CHAMPION

Setup and Installation Addendum

Setup and Installation Addendum
for
Two(2) Floors On One(1) Transportation Chassis
(All Wind Zones)

Set-Up and Installation Addendum for Hinged Roof Trusses:

A | CHASSIS SEPARATION AND SET-UP

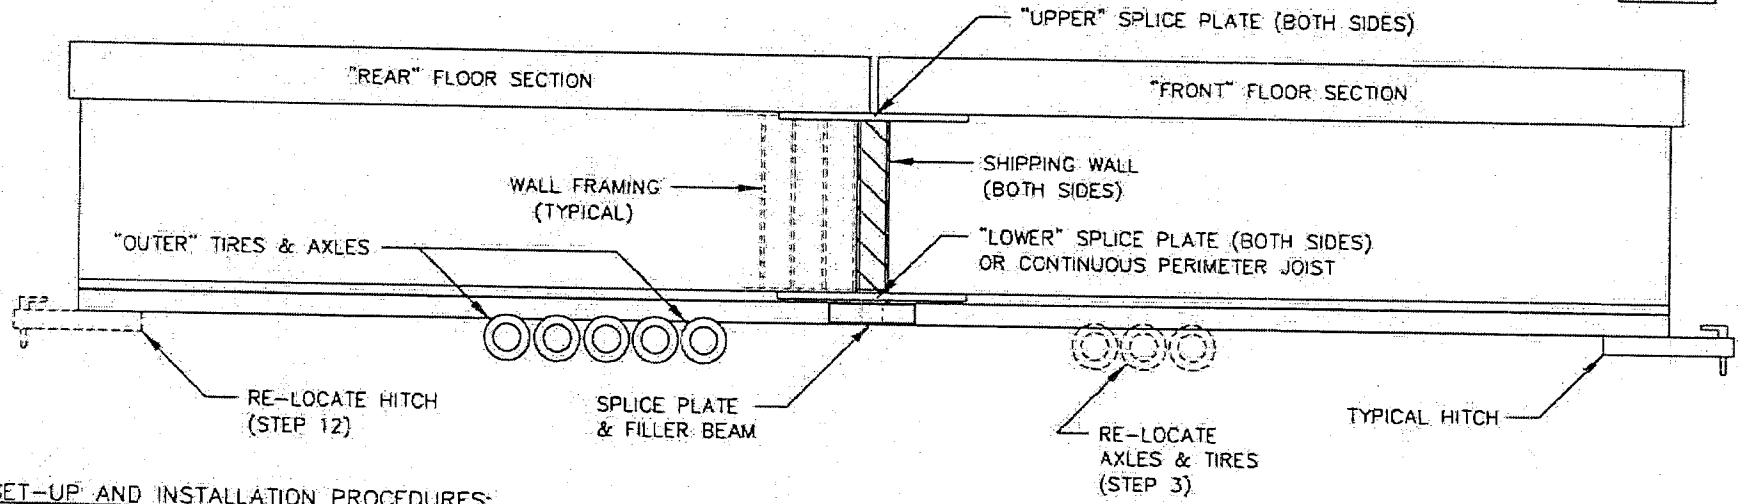
DAPIA SEAL	ENGINEER SEAL	MODIFICATIONS	TITLE: ADDENDUM	DRAWING NO.
PFS #05 Conforms to HUD MHCSS 11/30/06		(Was CEI: IN49.867.02) (A) REVISED DETAIL AND NOTES. MAT 12/16/04 (B) ADD NOTE 14. D.K. 10/27/06 (C) REVISE PAGE 4. D.K. 11/16/06	TWO(2) FLOORS ON ONE(1) TRANSPORTATION CHASSIS	IN49.867.02C
			DRAWN BY: CEI DATE: 10/26/04 N.T.S.	SHEET: 2 OF 4
			CALC. INDEX NO. :

1. MOVE THE HOME TO AN AREA WHERE IT CAN PLACED IN A LEVEL POSITION.
2. RAISE AND BLOCK THE FRAME IN ORDER TO RE-LOCATE AXLES AND TIRES. (SEE CHAMPION INSTALLATION MANUAL: SECTION 5.3, FIGURE 5.1)
3. STARTING WITH THE "OUTER" TIRES AND AXLES, REMOVE 2 OR 3 AXLES (ONE SHALL BE AN AXLE WITH BRAKE ASSEMBLY) FROM THE FIVE AXLE ASSEMBLY, AND MOVE THEM TO THE "FRONT" FLOOR SECTION.

B | TIE-DOWN DETAILS FOR OFFSET MULTI-SECTIONAL HOMES (FOR WIND ZONES II & III)

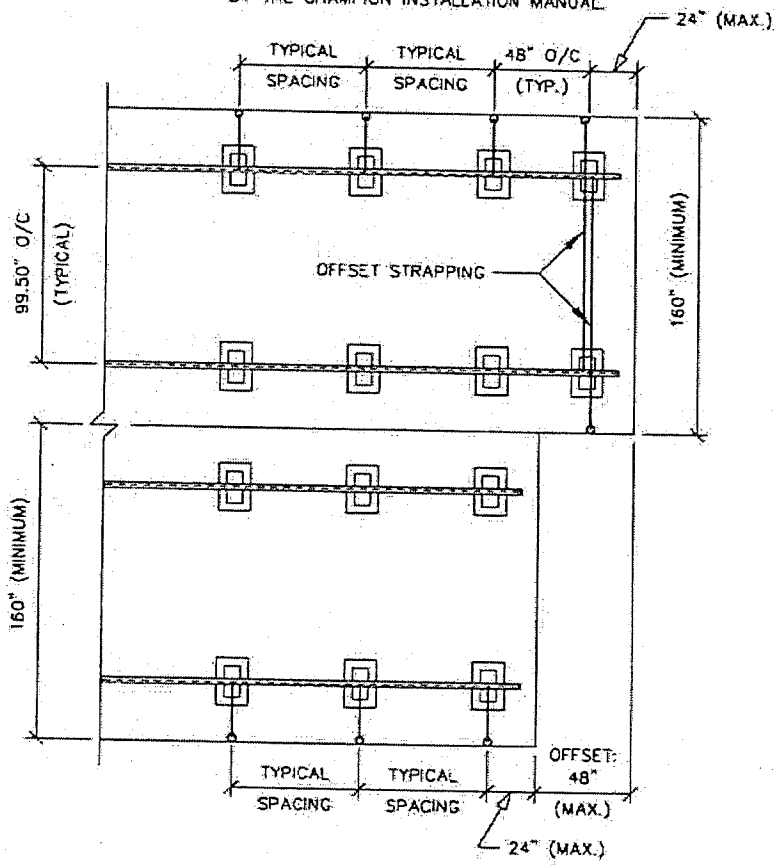
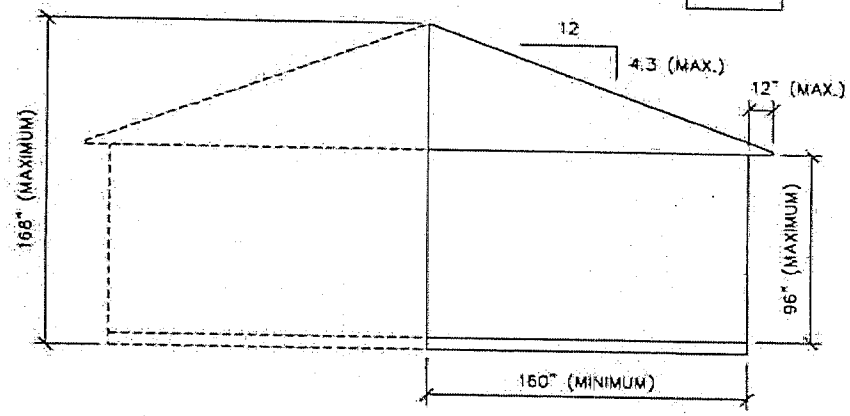
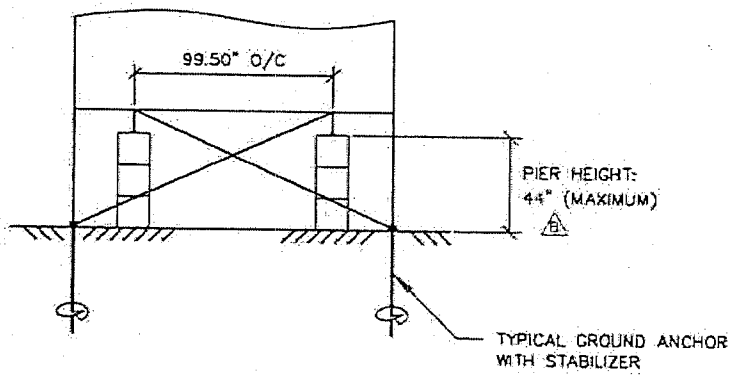
B REVISED PER HEIGHT. D.K. 10/27/06

C REVISED PAGE 4. D.K. 11/16/06

B | TIE-DOWN DETAILS FOR OFFSET MULTI-SECTIONAL HOMES (FOR WIND ZONE I)

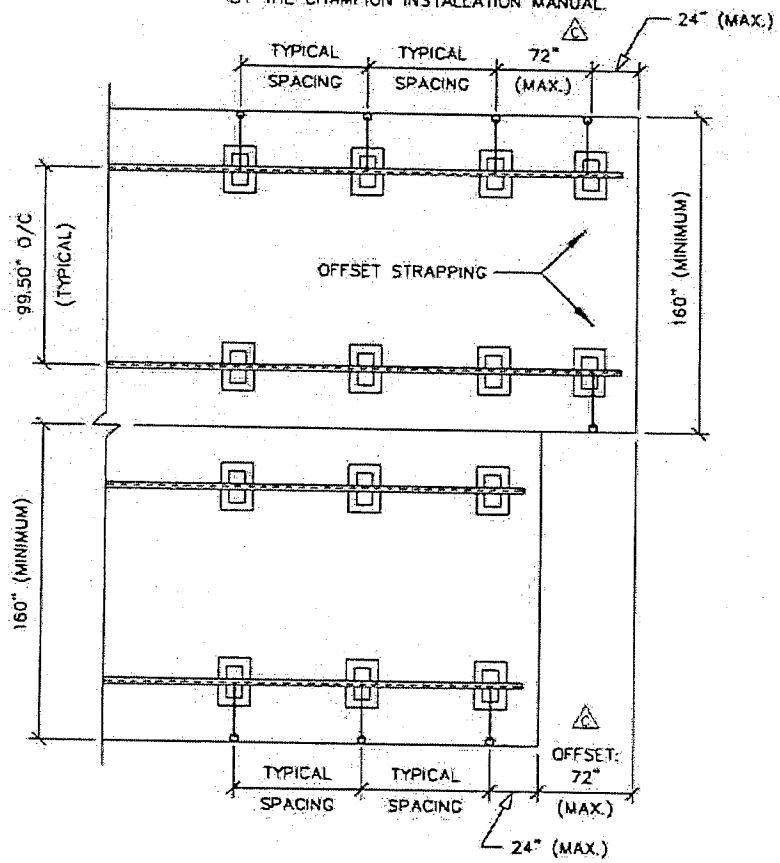
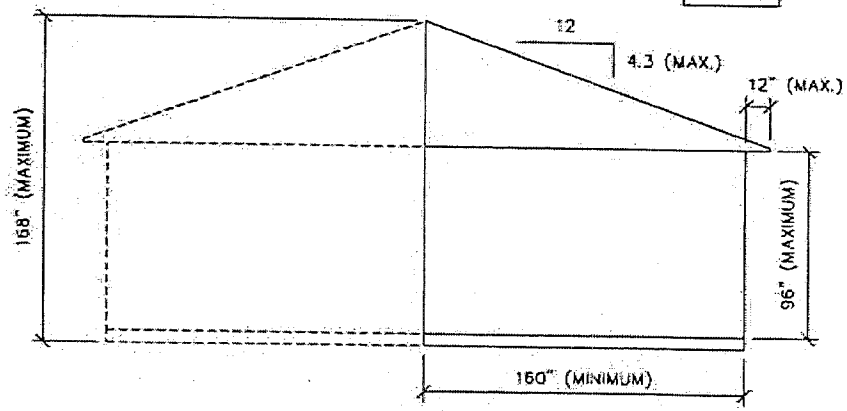
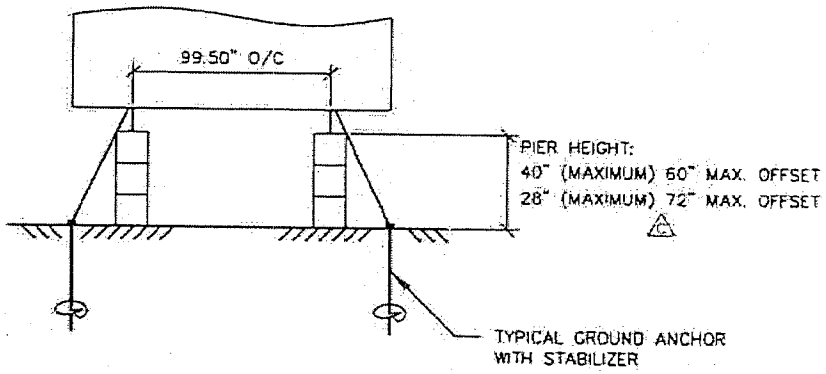
C REVISE OFFSET TO 72" MAX. D.K. 11/16/06

(D) SINGLE VERTICAL DETAIL

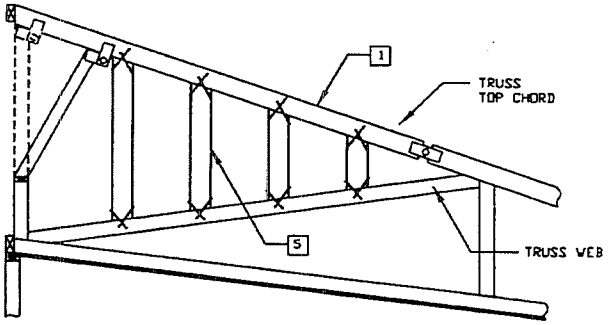
(B)	ADD LONGITUDINAL TIES & TRUSS CAP.	D.K. 06/16/04
(C)	ADD 4/12 ROOF PITCH.	D.K. 06/24/04
(D)	ADD SINGLE VERTICAL DETAIL TO PAGE 9.	D.K. 03/09/05
(E)	CHECK SCREWS FOR NDS 2001.	D.K. 05/25/06

A | OPTIONAL LISTED TRUSS RIDGE CAP

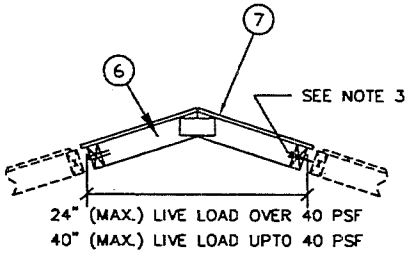
(B)	ADD LONGITUDINAL TIES & TRUSS CAP.	D.K. 06/16/04
(C)	ADD 4/12 ROOF PITCH.	D.K. 06/24/04
(D)	ADD SINGLE VERTICAL DETAIL TO PAGE 9.	D.K. 03/09/05
(E)	REVISE SCREWS FOR NDS 2001.	D.K. 05/25/06

1. ALL PURCHASED RIDGE CAP COMPONENTS SHALL BE LISTED FOR APPLICABLE LIVE AND DEAD LOADS, AND BE SPACED NOT TO EXCEED THEIR LISTING REQUIREMENTS.
2. RIDGE CAP FRAMING SHALL BE SPACED:
   FOR LIVE LOAD = 40 PSF (MAX.) AT 24" O/C.
   FOR LIVE LOAD = 80 PSF (MAX.) AT 16" O/C.
3. FOR ROOF LIVE LOAD = 80 PSF (MAX.):
   USE #8 x 3" WOOD SCREWS AT 9" O/C. (E)
